PASADENA WATER AND POWER

SUBJECT: National Aeronautics and Space Administration (NASA), Jet Propulsion Laboratory (JPL) Technical Memorandum (TM): Additional Investigation Results, January 31, 2007

Review and Comments of NASA's Jet Propulsion Laboratory 31-Jan-07 Technical Memorandum: Additional Investigation Results

REVIEW AND COMMENTS OF NASA'S 31-JAN-07 JET PROPULSION LABORATORY TECHNICAL MEMORANDUM: ADDITIONAL INVESTIGATION RESULTS

Figure 20

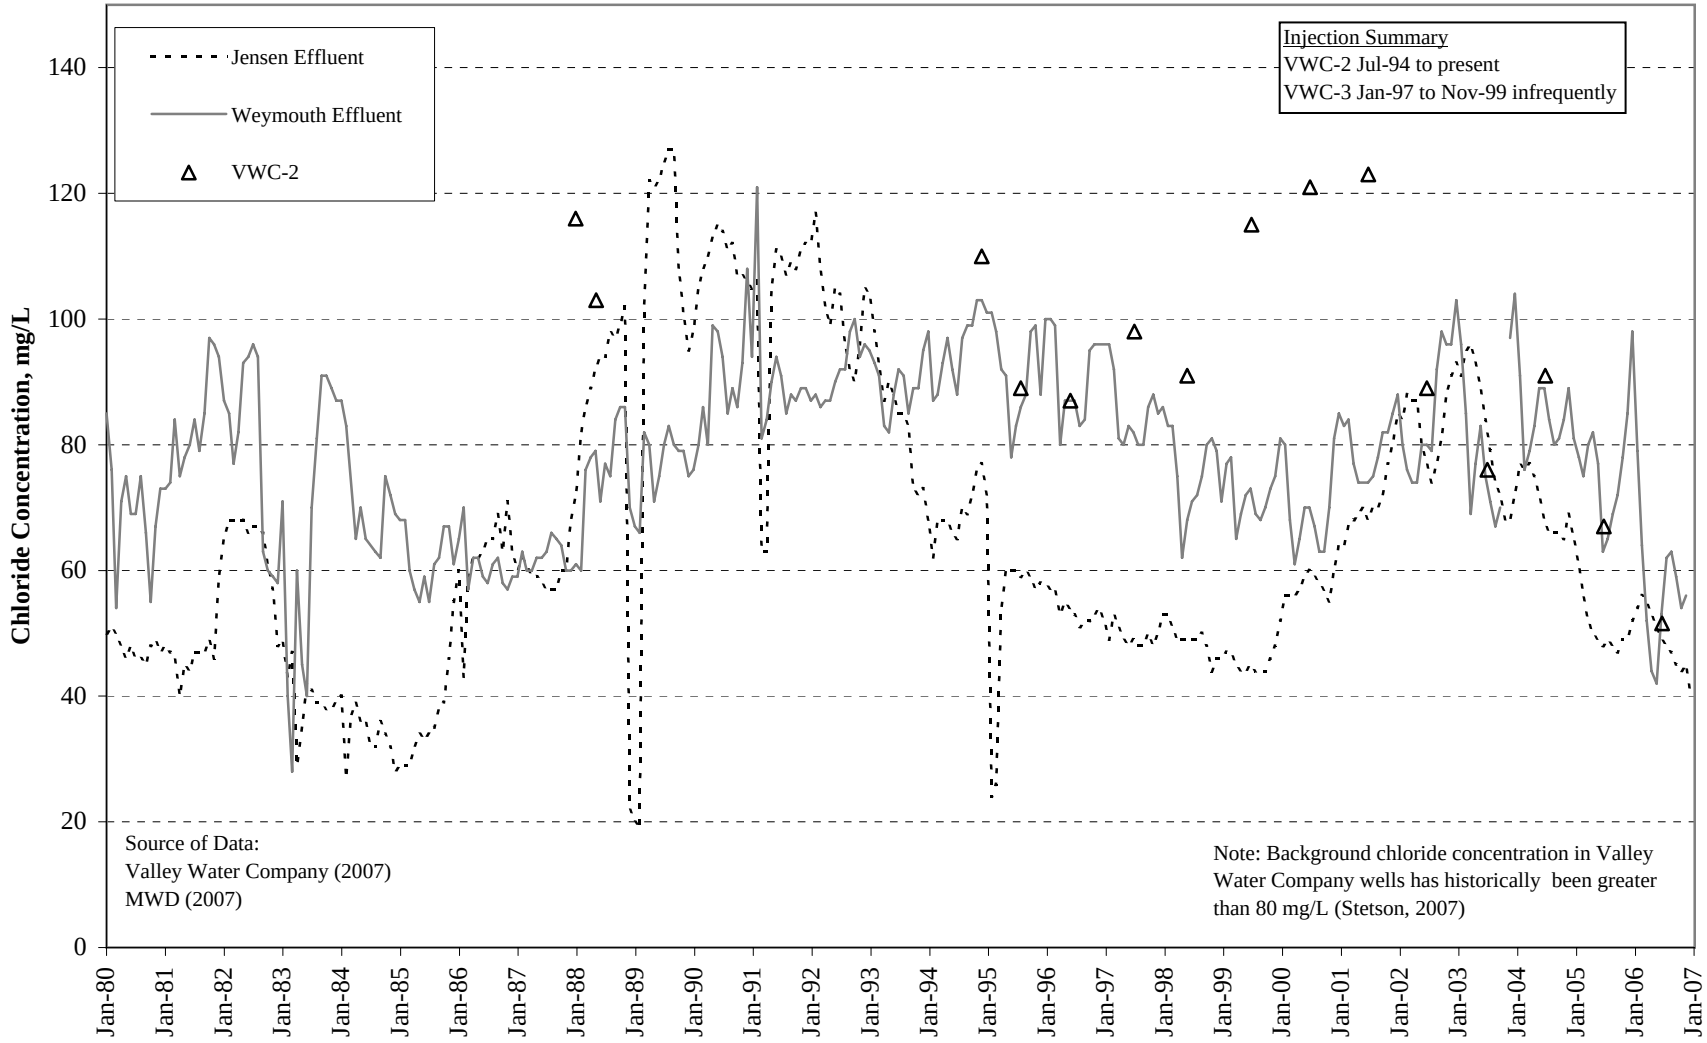
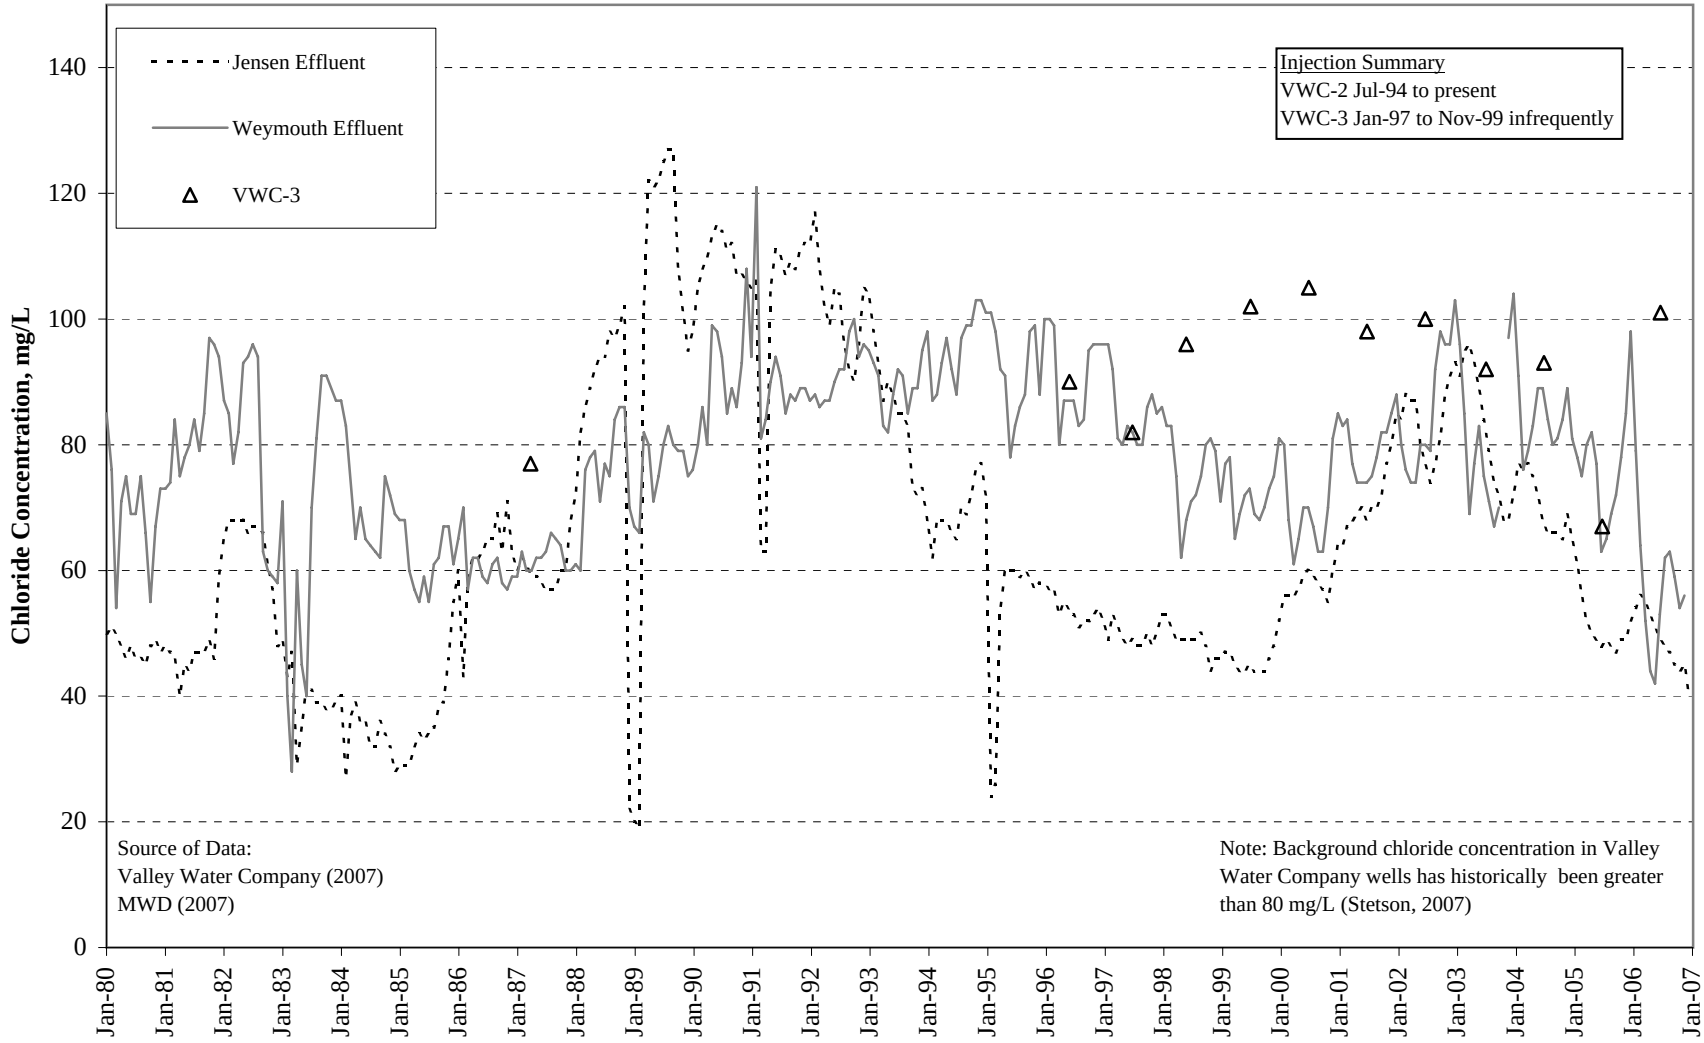
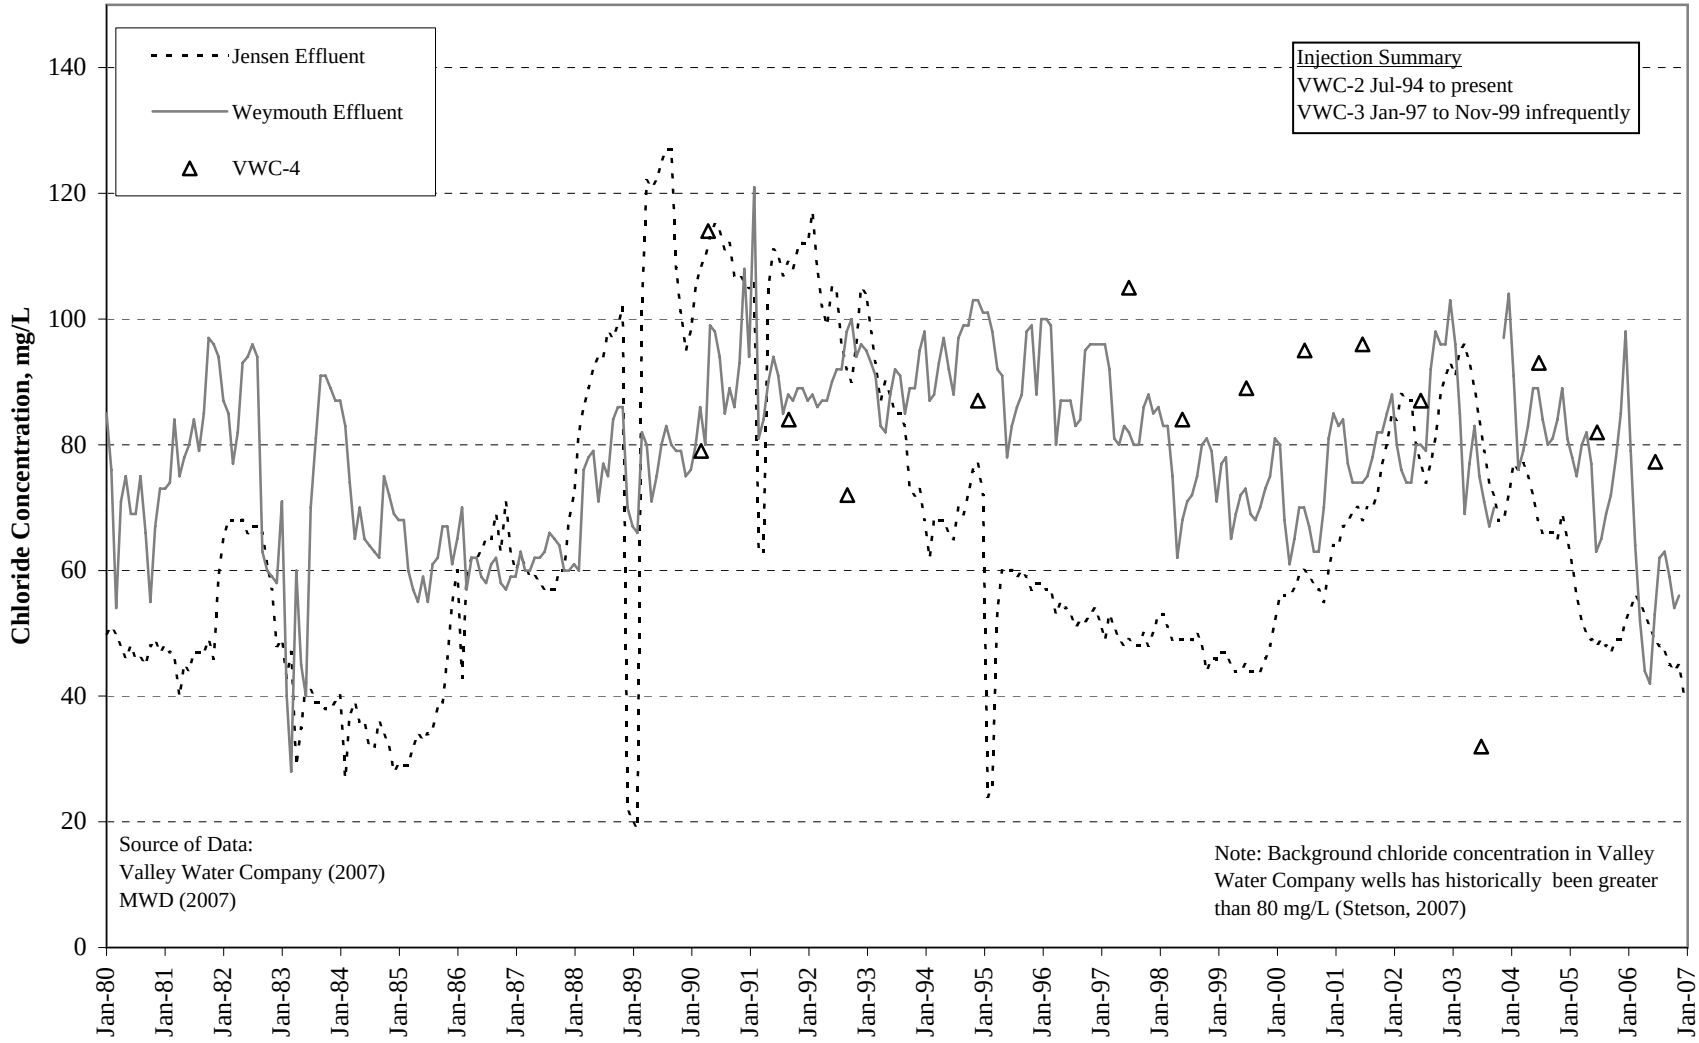
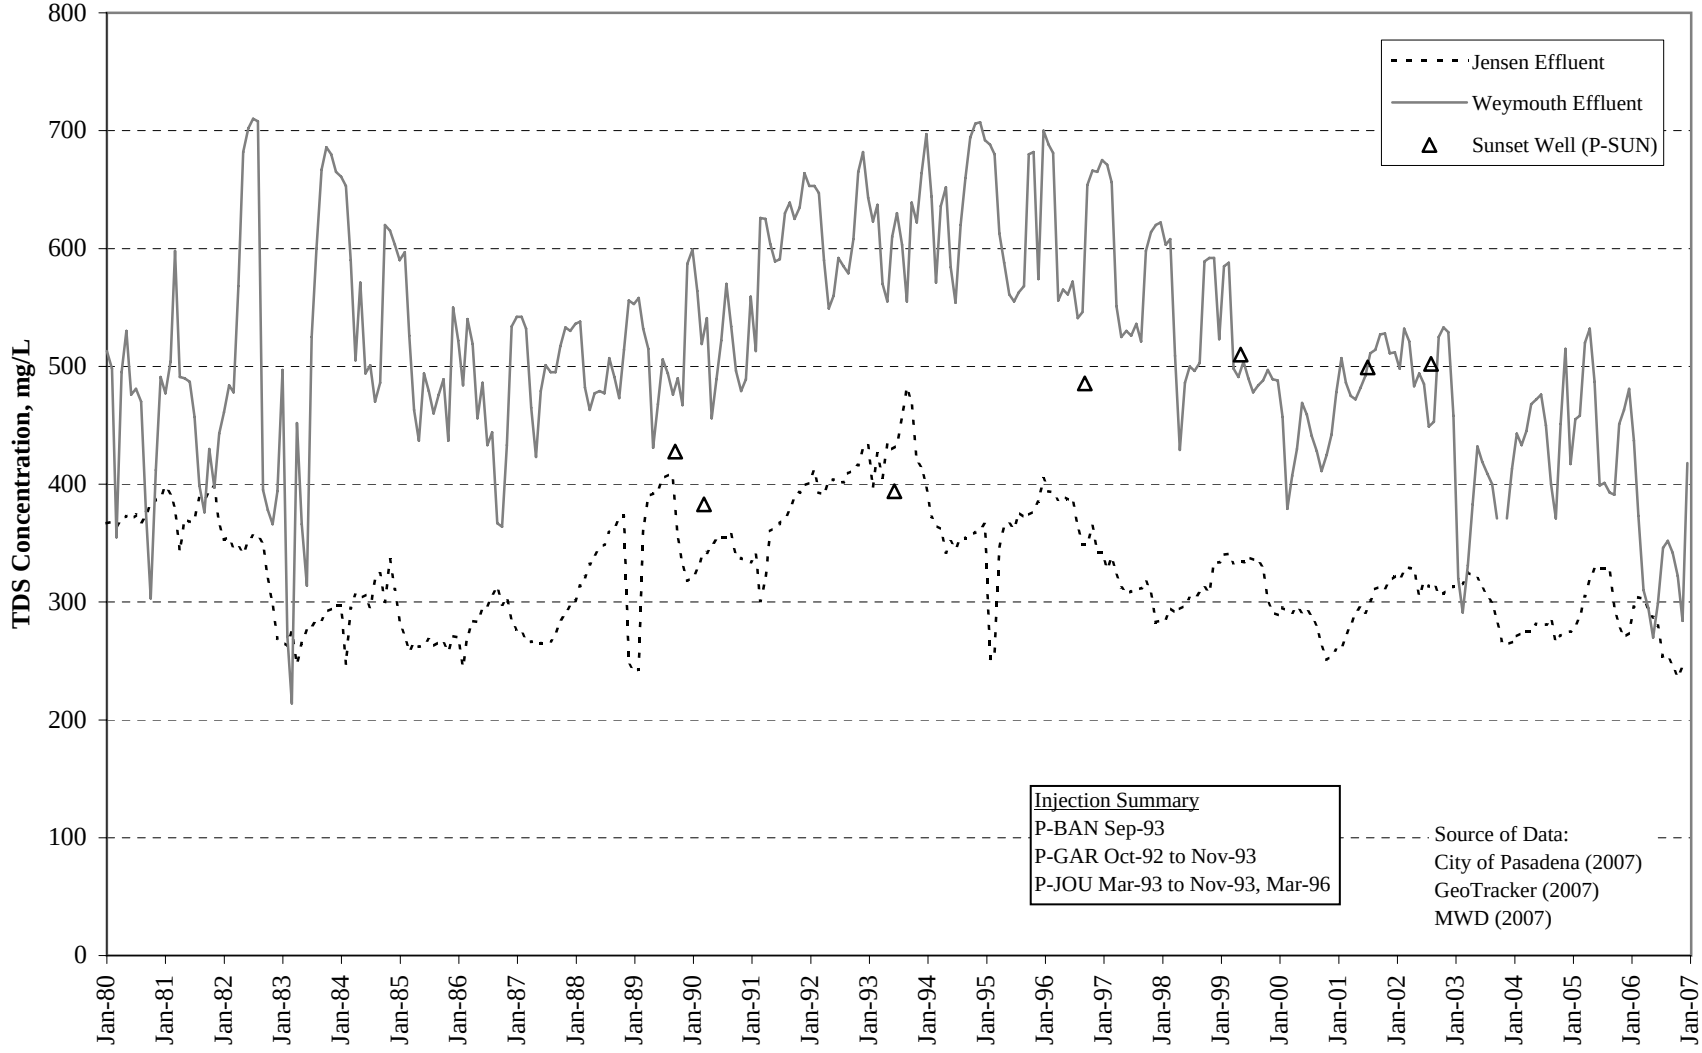
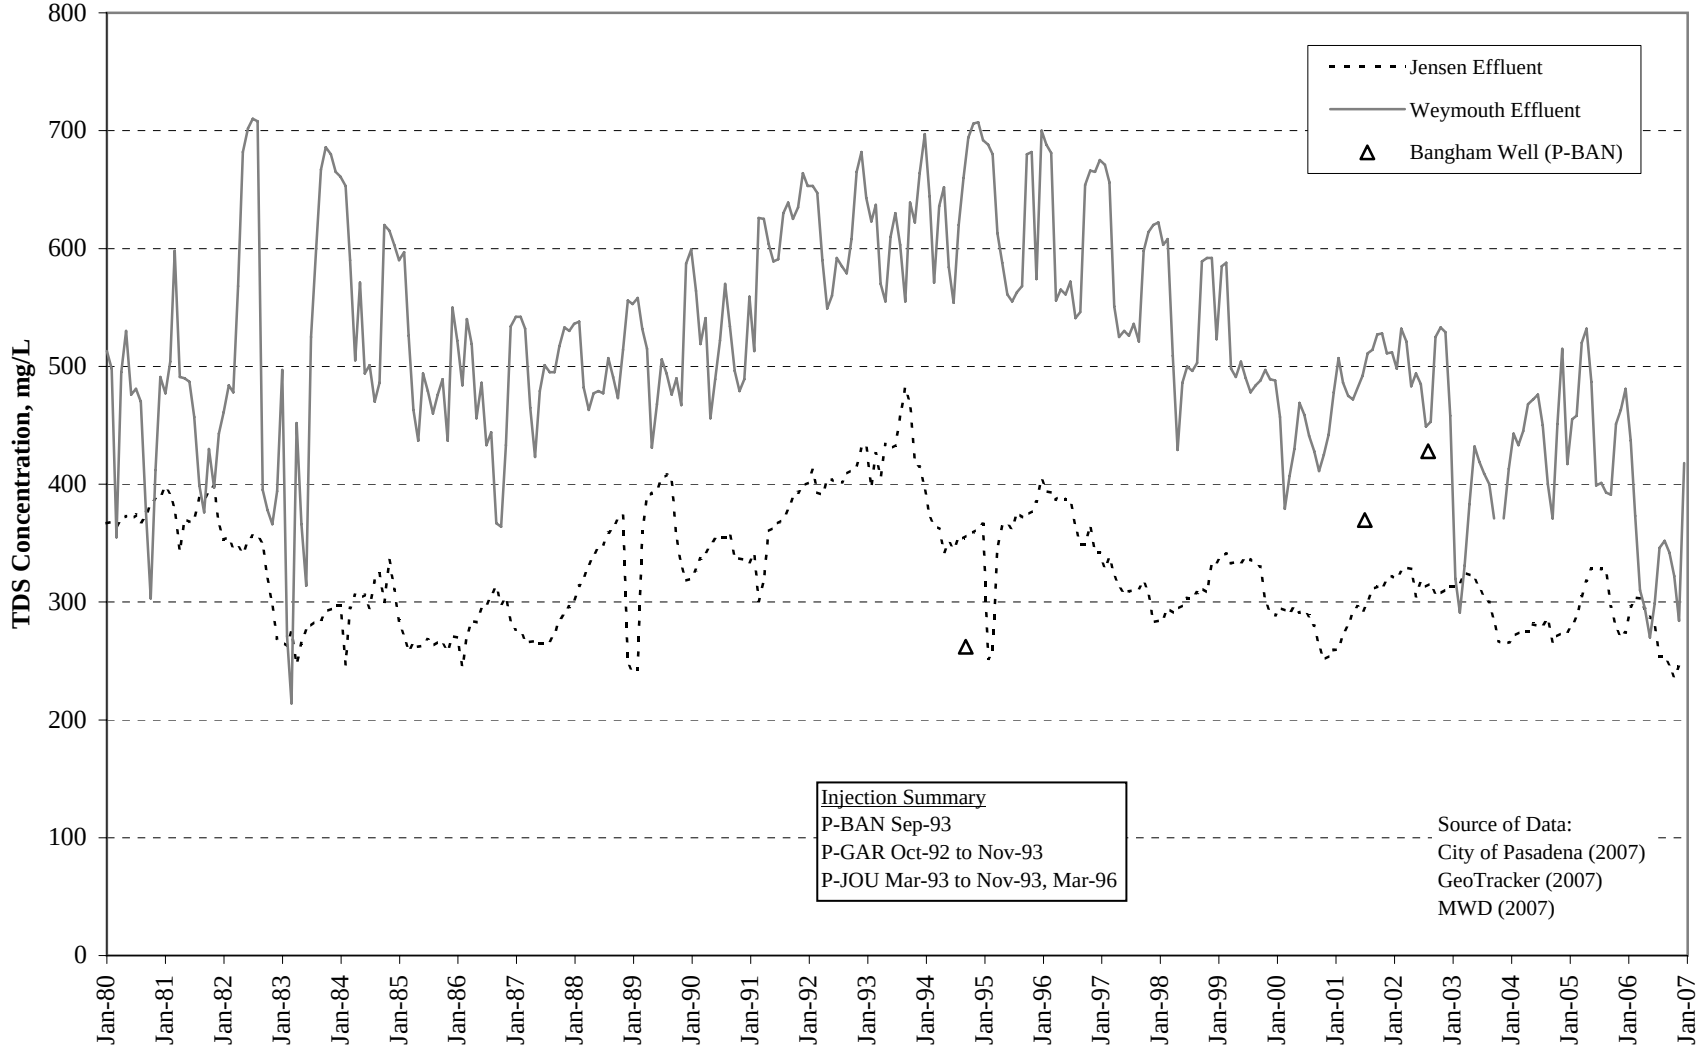
It is agreed that sulfate in the Basin has increased in some areas, possibly due to the importation of Colorado River Water and recharged as return flow including septic tank discharge in unsewered areas. Also, in the Sunset Reservoir and Valley Water Company wells, historical sulfate trends show a range of increases, no changes and decreases as shown in Figures 5 – 31, and summarized in Table 1.

If the mechanism described by NASA for concentrating perchlorate in the ground water to levels above the source/recharge water was valid, it would be expected that other salts, such as sulfate, chloride and TDS would also increase in the ground water to concentrations exceeding the recharge water. Figures 5 through 13 show that sulfate in ground water (both Sunset Reservoir area and Valley Water Company wells) have mostly remained at or below imported Colorado River and State Project water concentrations, while Figures 32 through 36 show perchlorate in ground water significantly higher than concentrations in imported water for wells hydraulically downgradient of the JPL facility.
